Re: L.E. Carpenter
Draft Remedial Investigation (RI) Findings Report,
Dated November 1989
Comments of EPA Region II and NJDEP

Comments on L.E. Carpenter Draft
Remedial Investigation Finding Report

Dated November 1989

Relative Flux

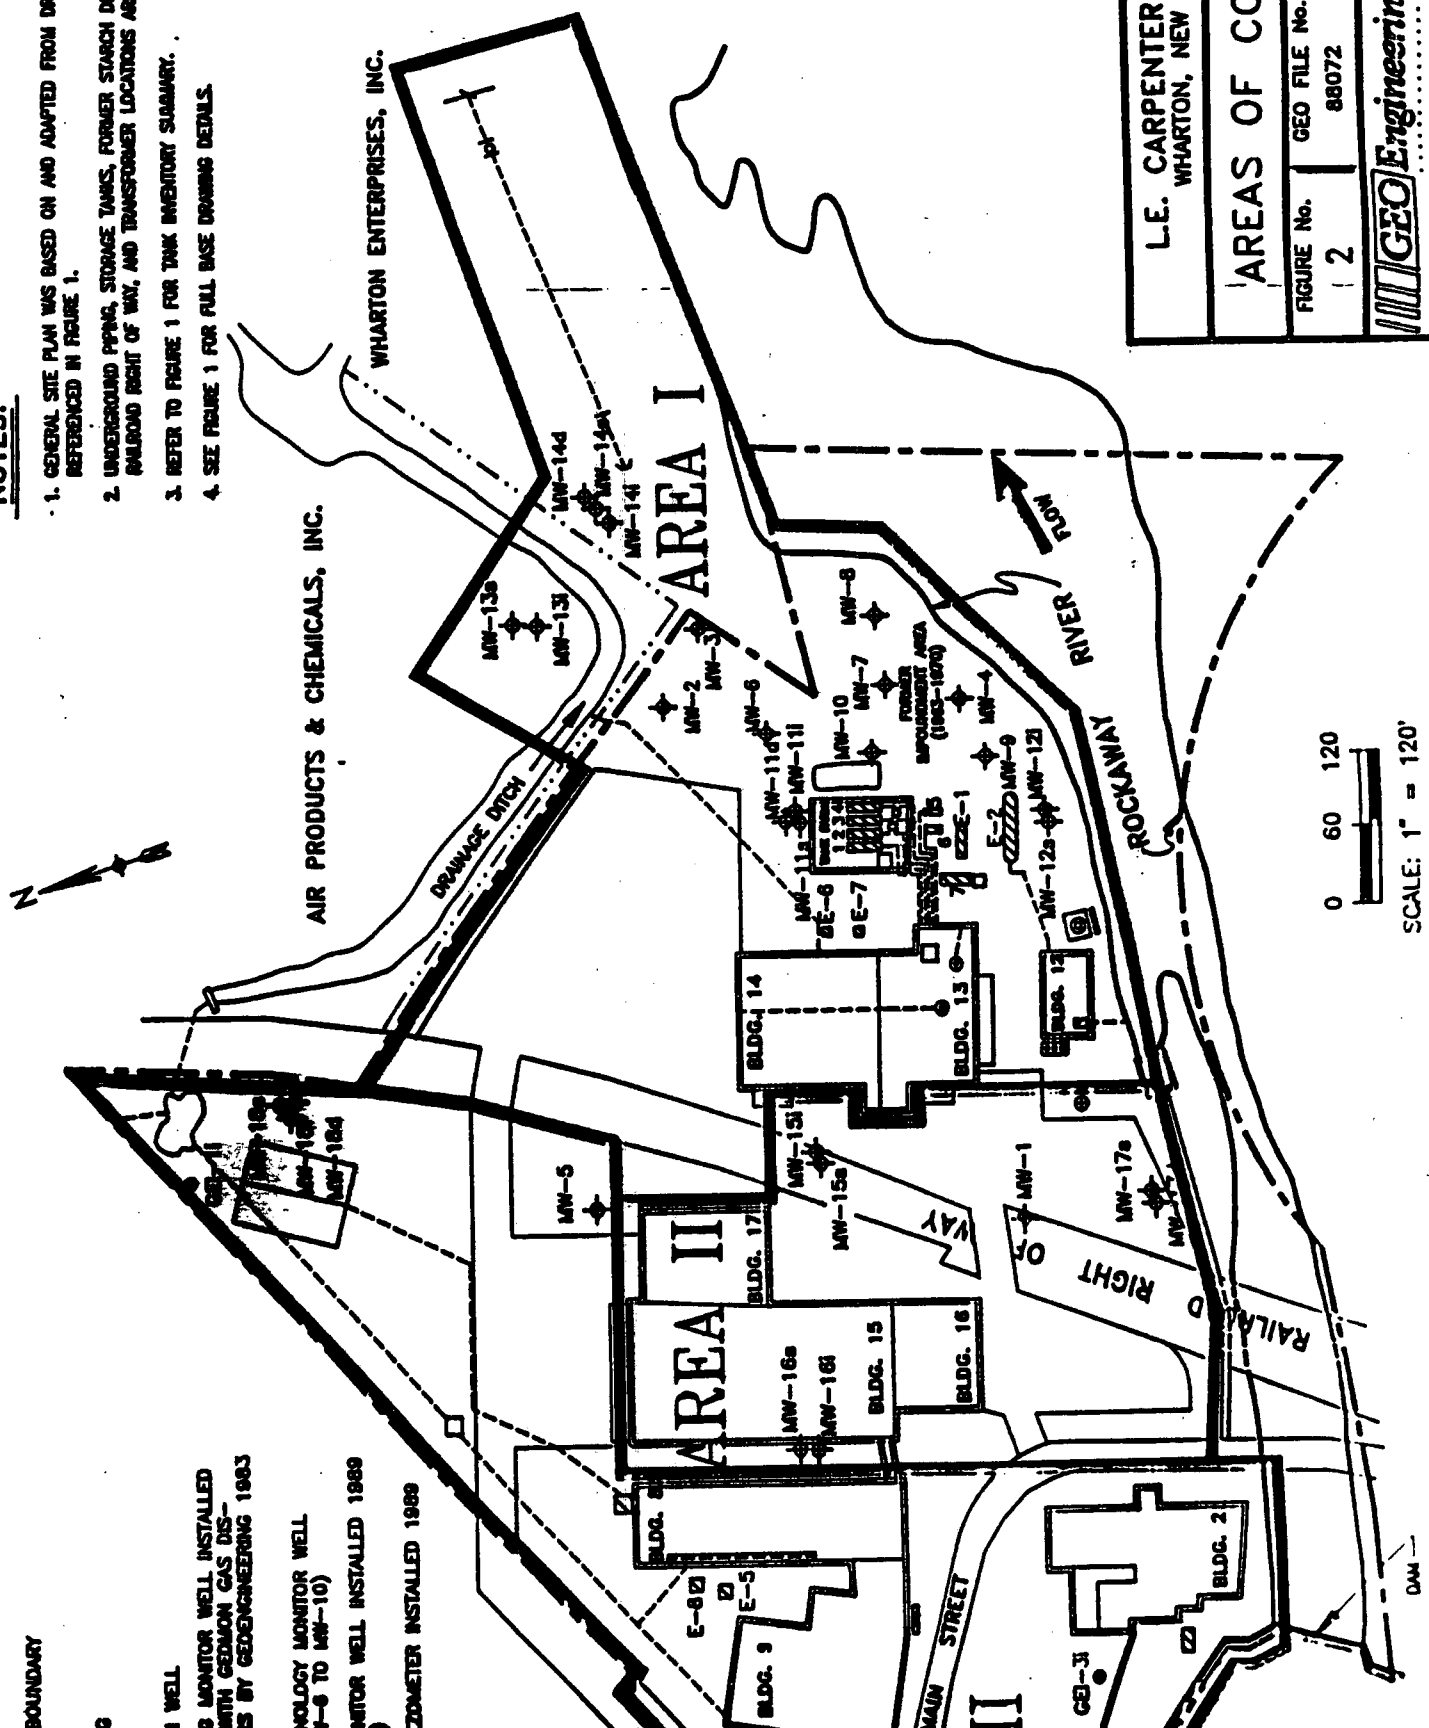
According to the Findings, an area between Washington Forge Pond and North Main Street was investigated during the Petrex soil gas survey "to characterize background volatile organic conditions in the soil." Yet, plate 2 from the Petrex Report identifies this area as having high ion counts, indicating high contaminant concentrations of toluene, xylene, and ethyl benzene in the subsurface and/or groundwater. Unless proper justification is provided in the RI Report for excluding this area, further investigation will be required in the next phase.

Petrex conducted a soil gas survey at the site to predict areas contaminated with volatile organic compounds (VOCs). Based on measuring the relative ion abundance of emissions from volatile compounds, in this case benzene, toluene, ethylbenzene and xylene (BTEX), several anomalies are indicated (Fig. 1). Of special

importance is the correlation between elevated ion abundance measurements detected in the vicinity of the tank farm and elevated concentrations of VOCs detected in soil and ground-water samples collected in this area. Conversely, similar elevated ion counts are reported in the vicinity of MW-17s and TP-4 but soil and ground-water samples collected from these locations report non-detect for BTEX.
